ClassNK PSC Bulletin

Date:	19 September 2017
No:	NK-PSC-11
Attachment	No / Yes: _____ page(s)

Cable penetration of ECDIS

Cable penetration in ECDIS console box after rectification
(Sealing the opening with non-combustible material)

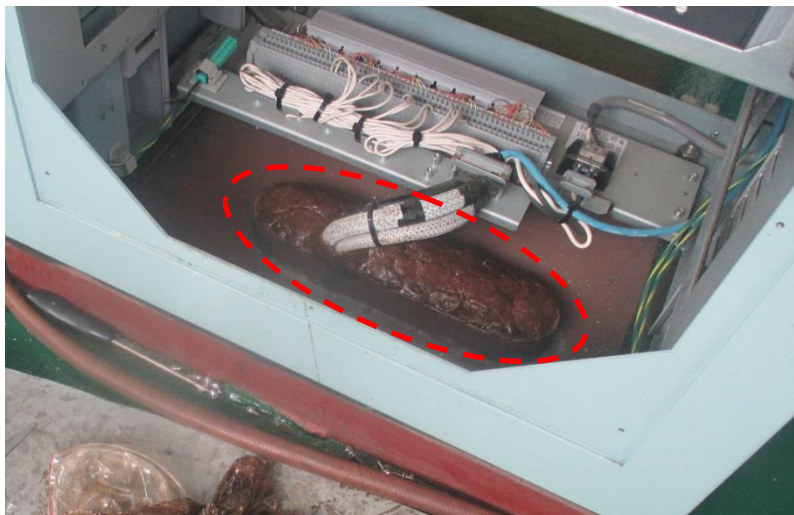
Opening for cable penetration of ECDIS not sealed

During recent PSC inspections in China, it has been reported that PSC officers have pointed out that openings for cable penetration of ECDIS (navigation bridge deck) were not filled up (sealed).

The cause of this deficiency was due to the fact that although an opening was made for cable penetration on the navigation bridge deck when installing ECDIS while the vessel was in service, no measures were taken to ensure the fire integrity of the navigation bridge deck after such installation (such as sealing the opening with suitable non-combustible material).

In this regard, please confirm once again whether fire integrity is ensured or not at cable penetration openings made for the installation of ECDIS.
